Subject: AP1000 COL Response to Request for Additional Information (TR 36)

Response to Request for Additional Information on Technical Report No. 36

RAI Response Number: RAI-TR36-012

Figure 1-1  
Steam Line Break

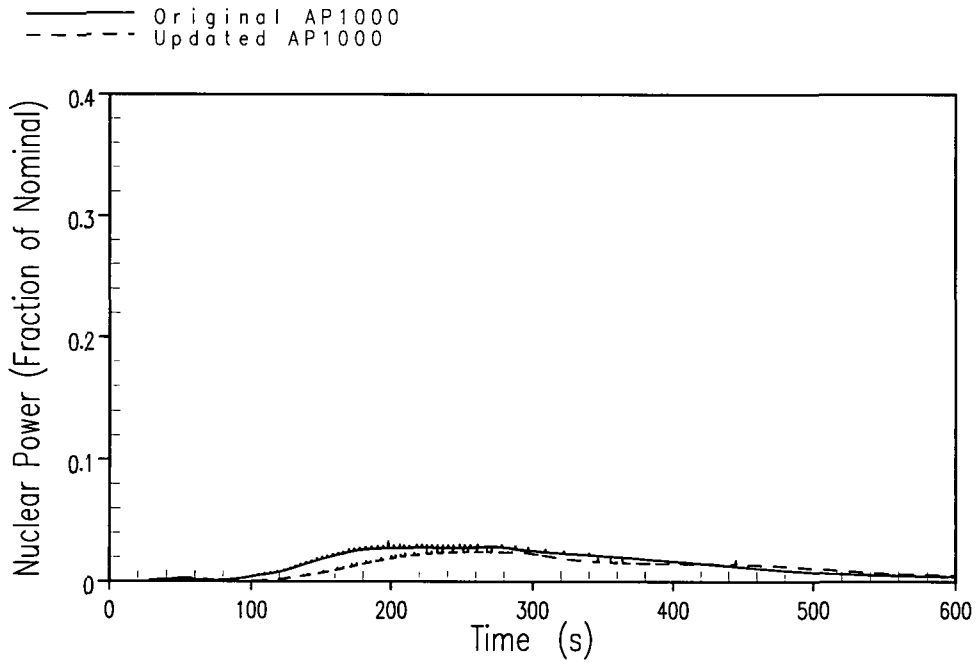
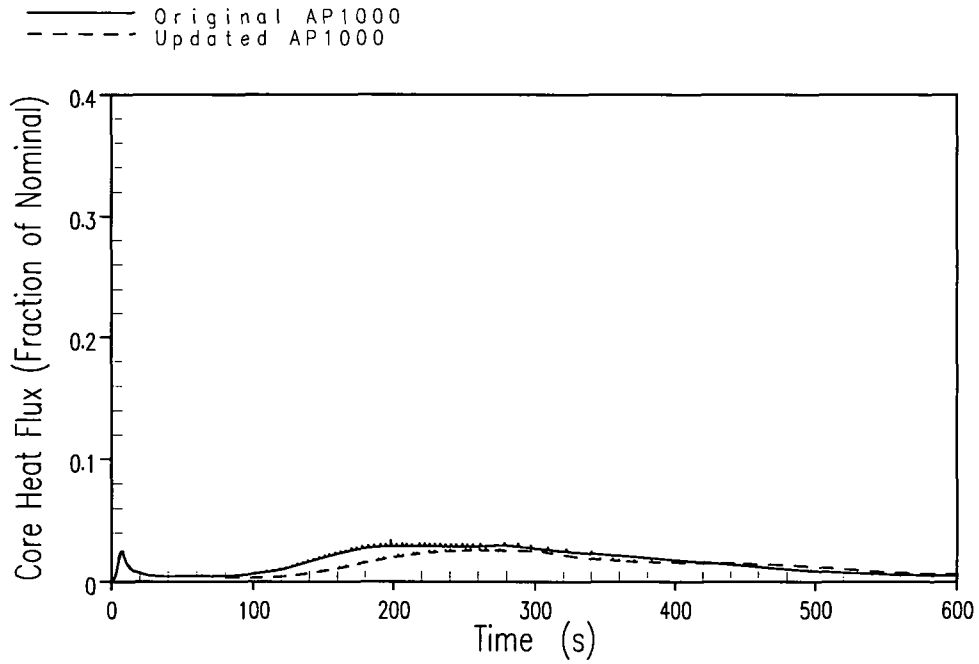
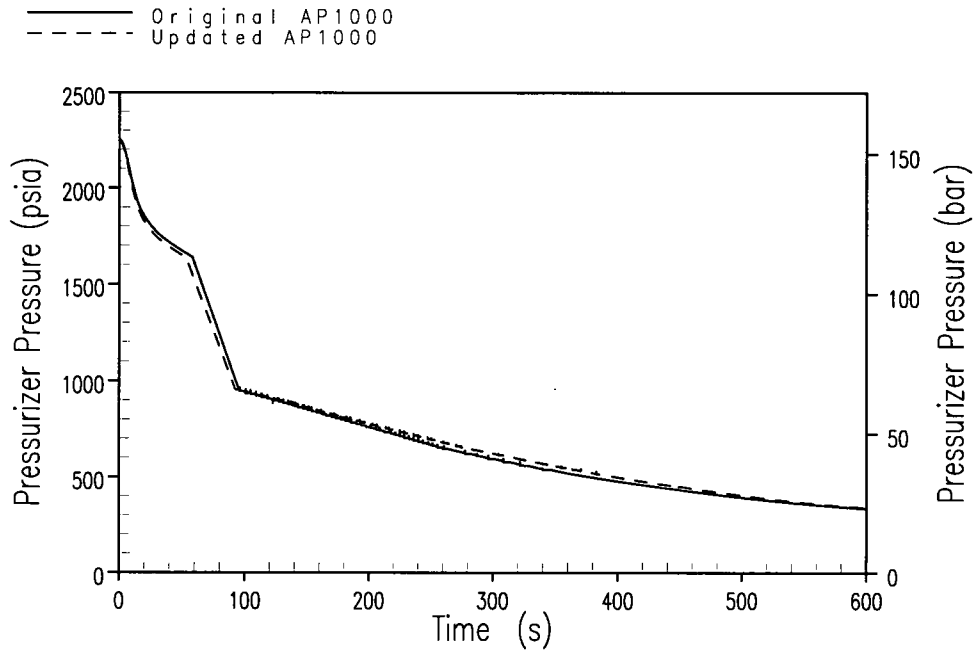
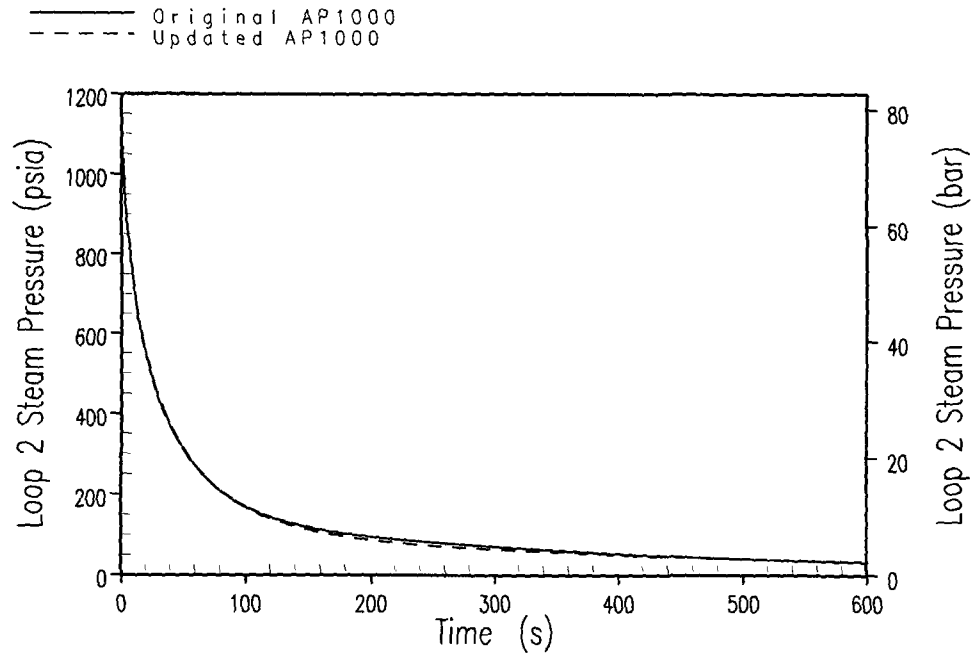
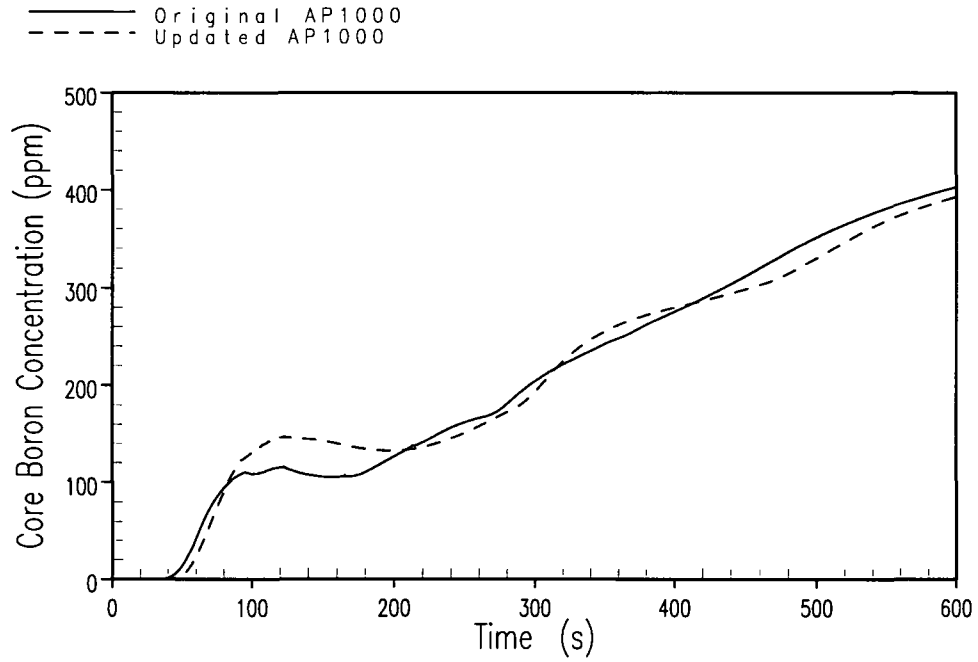
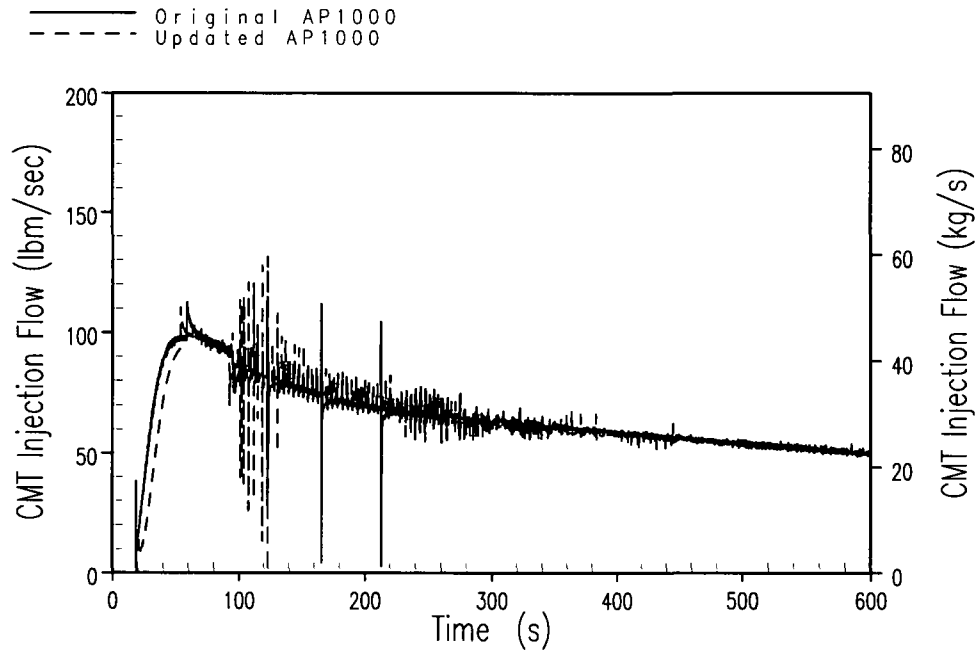
In the request for additional information (RAI) response in the Enclosure I to September 22, 2006 letter, Westinghouse qualitatively discussed the effects of the pressurizer design changes on the depressurization and Automatic Depressurization System (ADS) flow rates, and categorically stated the chapter 15 analysis remains valid and bounding.

The pressurizer changes affect many parameters such as the cross-sectional area of the pressurizer, pressurizer vessel height, initial pressurizer water level, pressurizer setpoints, ADS stages 1, 2, and 3 elevation and pressurizer heater length. We are concerned about the combined effects of the values changed for the above parameters on the thermal hydraulic response during transient and accident conditions. We determined that the qualitative statement in the RAI response is not sufficient to resolve the RAI issue. We request Westinghouse perform the quantitative analyses for the limiting event for each of the following Standard Review Plan chapter 15 event categories:

A full double ended steam line rupture analysis from hot zero power conditions was performed for the updated AP1000 configuration. A comparison of the results from the updated analysis to those of the analysis for the original AP1000 configuration is shown in Figures 1-1 through 1-10. Table 1-1 provides the sequence of events for the original and the updated AP1000 configuration.

The transients results of the updated plant configuration during a steam line break are very similar to those of the original plant configuration. Core state parameters (inlet temperature, pressure, flow) remain essentially the same. The return to criticality occurs at essentially the same time in the updated AP1000 configuration. Following the return to criticality, the core power is slightly less for the updated AP1000 (see Figures 1-1 and 1-2). Early core makeup tank flow is slightly improved with the updated AP1000 plant configuration which yields a slightly lower core power. Based on these results, the existing steam line break analysis is bounding for the updated AP1000 plant configuration.
